10215 Menlo Avenue, Silver Spring

HISTORIC PRESERVATION COMMISSION STAFF REPORT

CASE NUMBER: 31/7-90(0)

SITE/DISTRICT NAME: Capitol View Park PROPERTY ADDRESS: 10215 Menlo Avenue

Sketch of Fence with  
Entrance Door

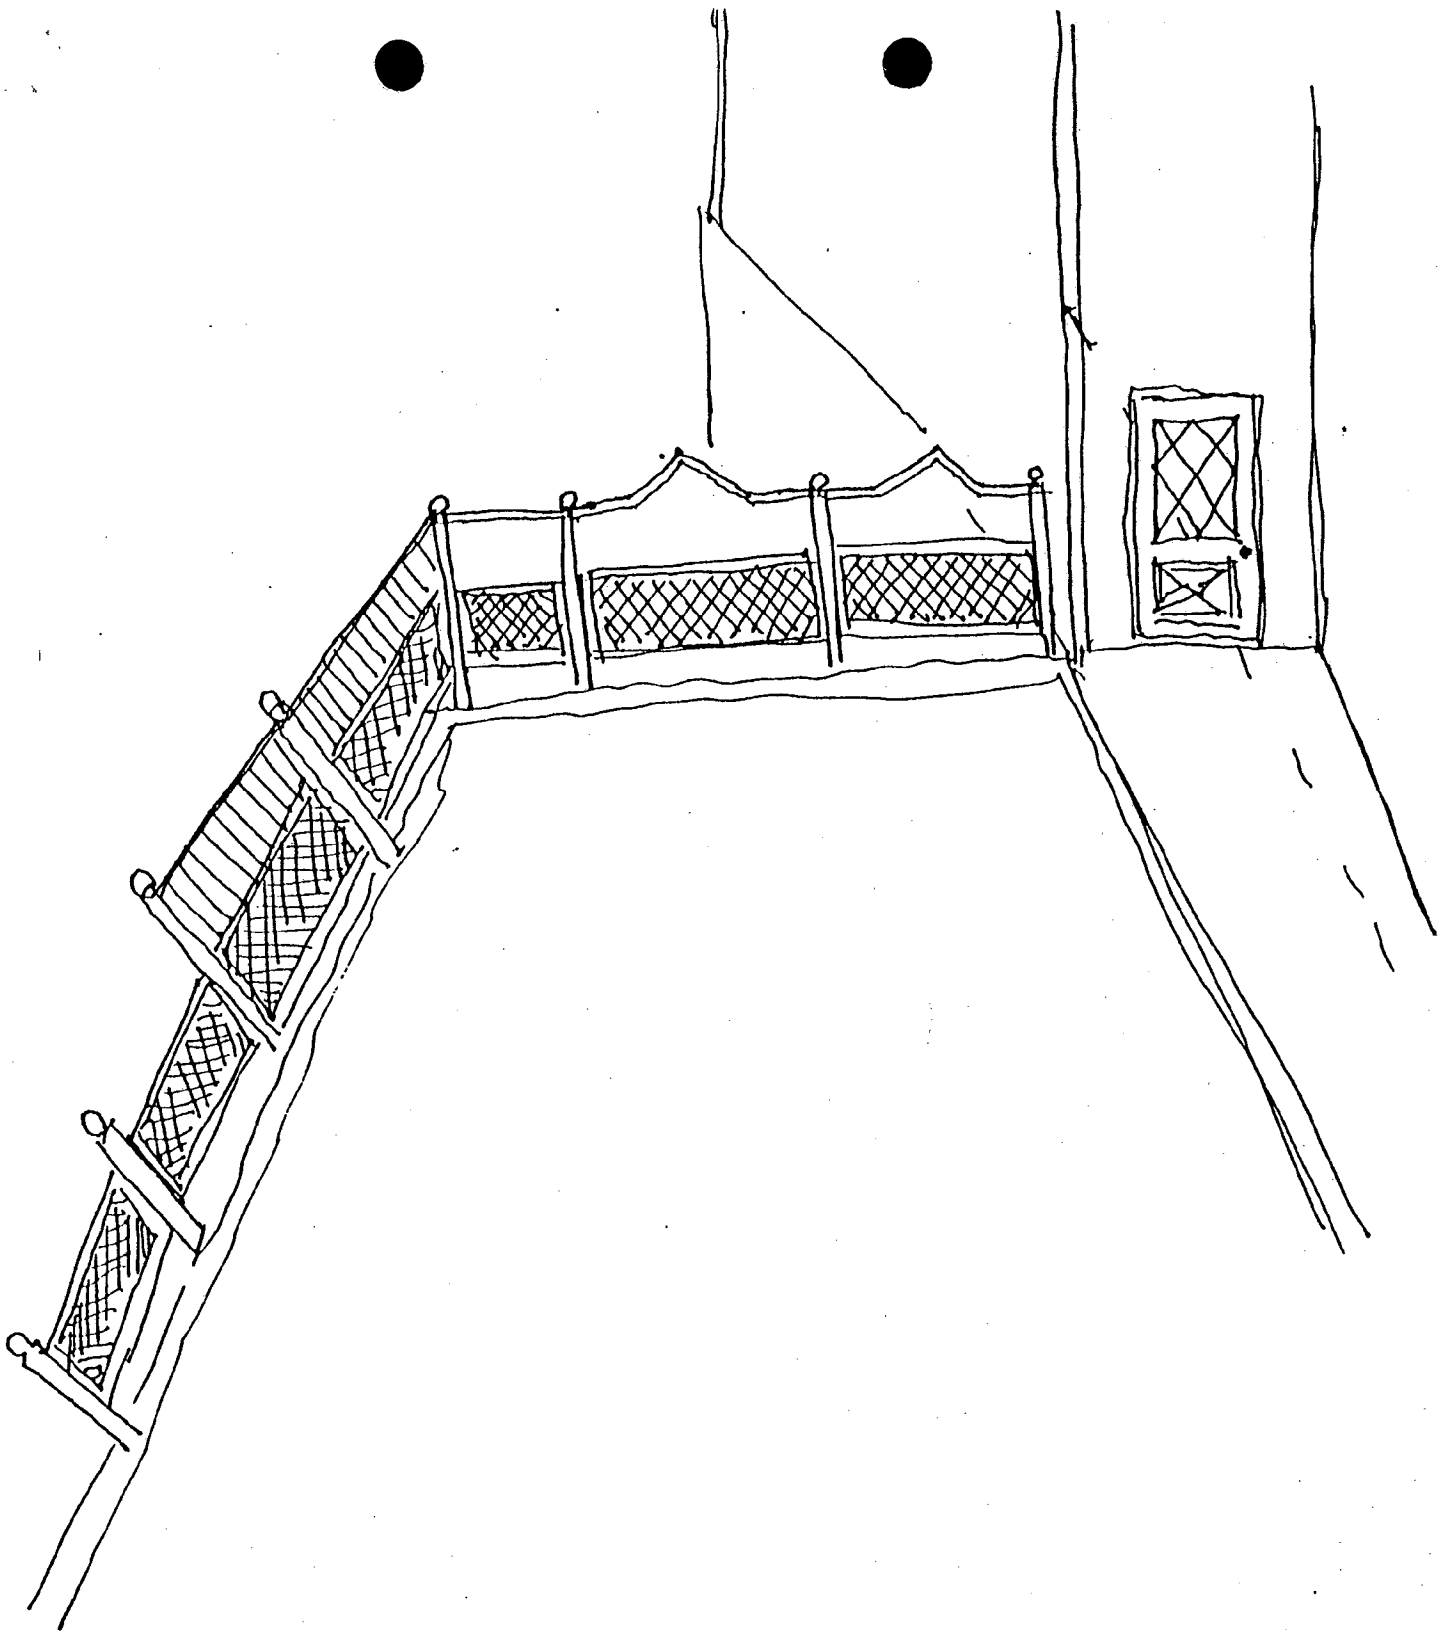
13. Posts have been set to install a privacy/safety fence in the area of the driveway built up by an existing retaining wall.

Reason: The original retaining wall places the "back" side of the driveway approx. 5' above the lower level making it possible for someone to fall off of. Also, both houses 10217 and 10215 have entrance doors that kind of "face" one another and the fence would add some privacy for both entrance areas. A sketch is enclosed of the proposed fence.

FRONT ELEVATION

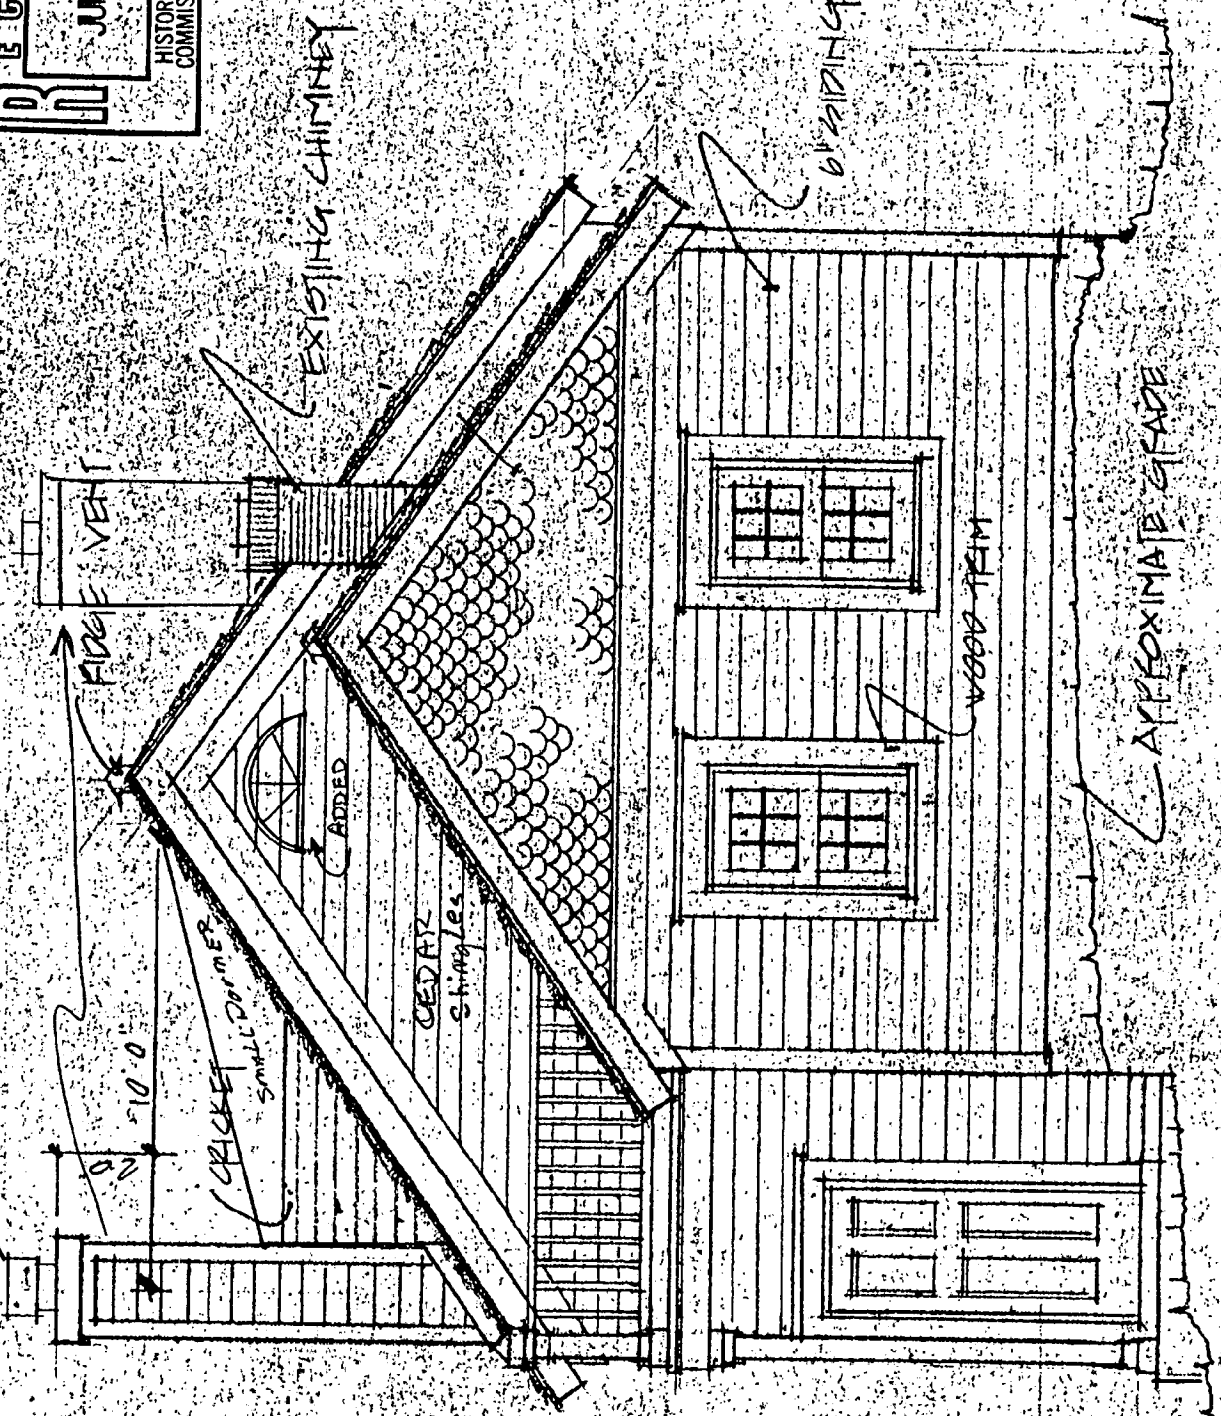
1. The new front gable will be sided with cedar shingles as is the original gable in the approved design. The shingles look so nice on the smaller original gable we decided to continue them on the new area instead of the masonite siding. The front gable louver has been changed to a similar sized half round window.

2. The "attic" space that was created by the new gable roof (over the existing shed roof) was so nice that it was decided to utilize this space. Consequently the rear gable end louver has been changed to a Palladium style window unit and two skylights on the north side new roof have been added. Code requirements for ceiling ht. made it necessary to add a small shed dormer roof where the original roof cricket was.

3. The fireplace had to be relocated so the chimney now comes through the south instead of the north side of the new gable roof.
- There have been no changes in scale or dimensions from the approved design.

REAR ELEVATION

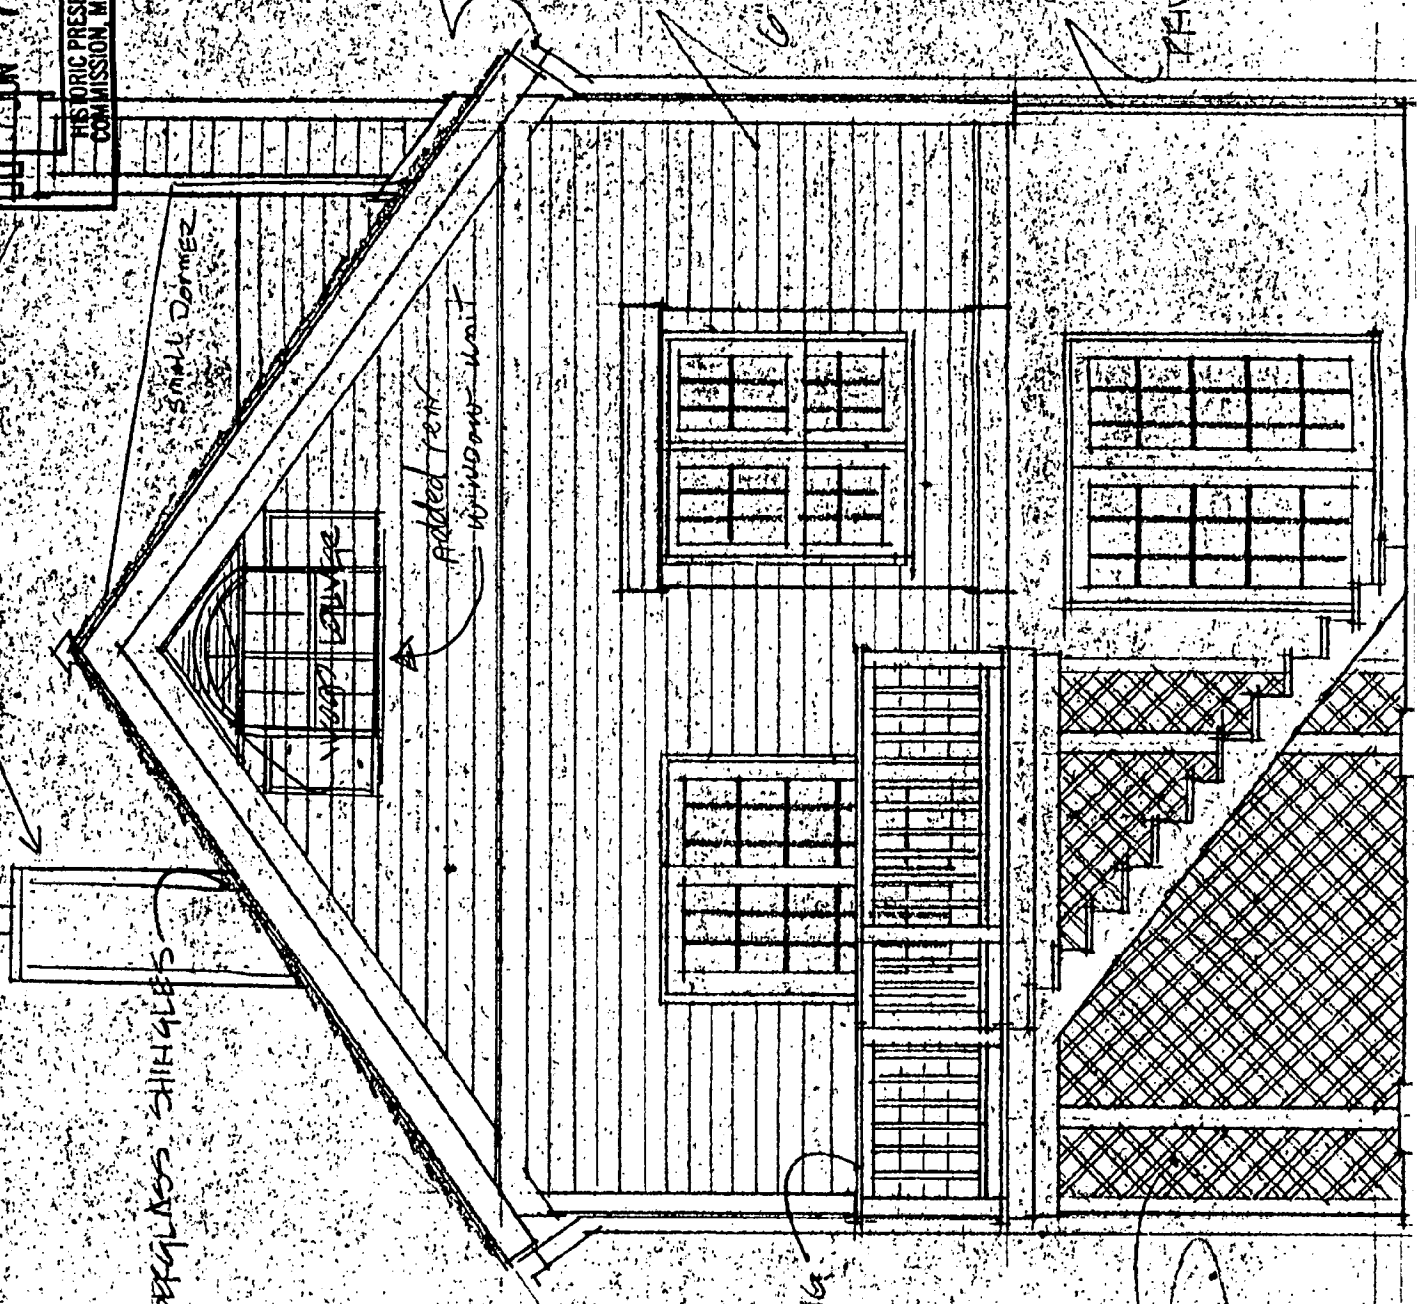
MOVED CHIMNEY

SMALL DORMER

ADDED 10" WINDOW UNIT

Sketch of Fence with  
Entrance Door

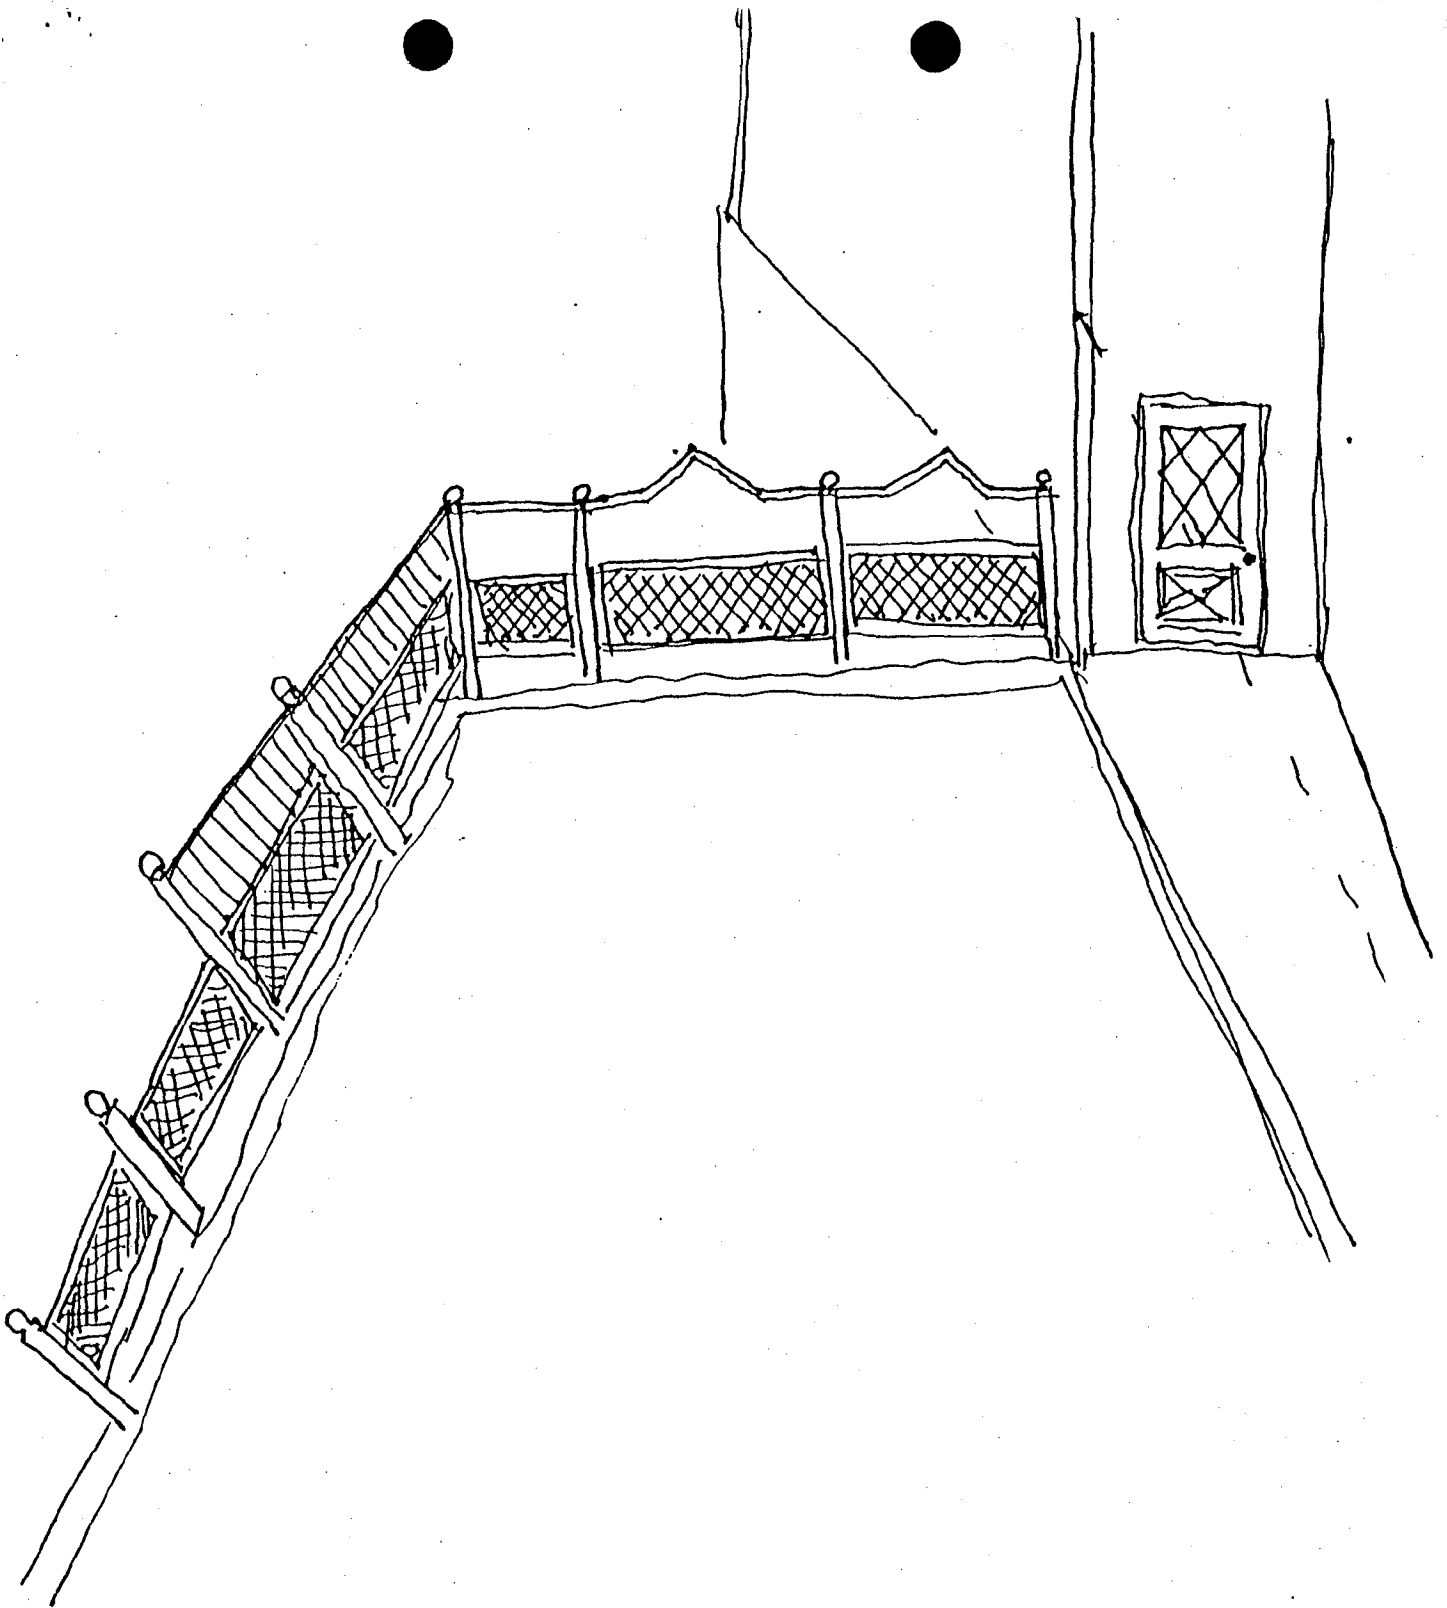
13. Posts have been set to install a privacy/safety fence in the area of the driveway built up by an existing retaining wall.

Reason: The original retaining wall places the "back" side of the driveway approx. 5' above the lower level making it possible for someone to fall off of. Also, both houses 10217 and 10215 have entrance doors that kind of "face" one another and the fence would add some privacy for both entrance areas. A sketch is enclosed of the proposed fence.
